Office Action Summary

10/562,854

CERRUTI ET AL.

F i g. 1 5 (b)

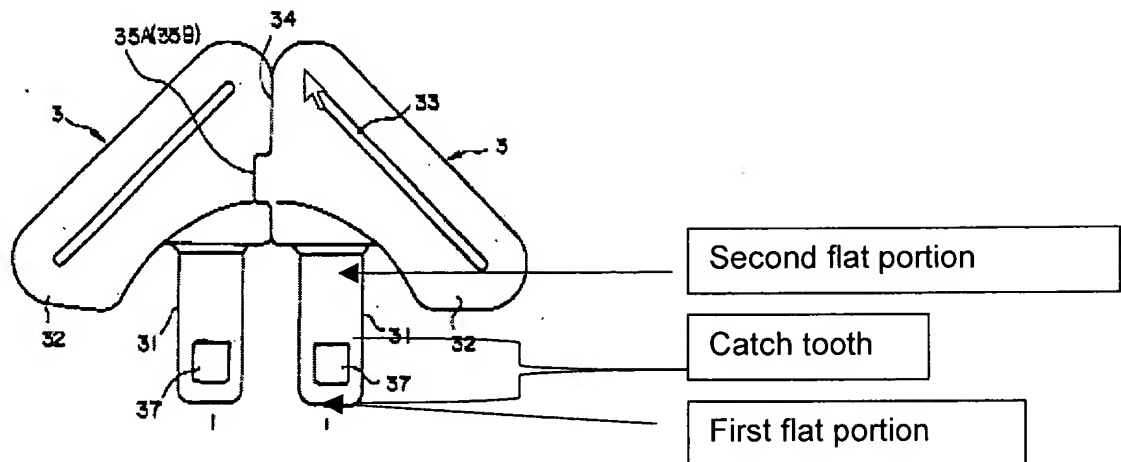
Koyanagi discloses a coupling device for restraining belts, comprising a body (10) intended to be connected to at least one belt branch (2), and a pair of tongue elements (3) intended to be connected each to a respective belt branch, wherein each tongue element includes an attachment point (33) for connection with the respective belt branch and a stem portion (31) arranged to be received and locked in the body, said stem portion forming a catch tooth represented by the area surrounding and including the hole (37), wherein said catch tooth is for locking the tongue element in the body. (See Fig. 4 and 6a) Further, each tongue element comprises of a metal insert that is partially covered by a coating, but said tongue element, including the metal insert, is not wholly covered or coated. (See col. 5, lines 9-17). However, it would have been obvious to one having ordinary skill in the art at the time the invention was made to have covered the entire tongue element(s), since it has been held to be within the general skill of a worker in the art to select a known material on the basis of its suitability for the intended use is a matter of obvious design choice.

Koyanagi further discloses that the metal insert of each tongue element comprises an essentially flat portion having a first part extending into the attachment portion and a second part extending into the stem portion of the tongue element. As for the limb, such a modification to the metal insert would have involved a mere change of shape of an element. A change in shape or form is generally recognized as being within the level of ordinary skill in the art. Further, nothing essential or unexpected is offered from this shape.

Koyanagi also discloses that the body comprises of a latching mechanism that includes a locking means (20,22) arranged to be moved in a perpendicularly direction to the direction of insertion of the stem portions of the tone elements into and out of the body from a coupled position, in which the locking means engages the catch teeth of the tongue elements to prevent the latter from being ejected from the body and a released position, in which said locking means disengages from the catch tooth, thus allowing the ejection of the elements from the body. (See Fig. 6a)

Also disclosed by Koyanagi about said tongue elements are connecting members (35A,35B) for ensuring the alignment of the elements. (See Fig. 4 and col. 5, lines 20-32). Further, said connecting members comprise at least a projection (35B) formed by the one tongue element and at least one cavity (35A) provided in the other tongue element to receive the respective projection.
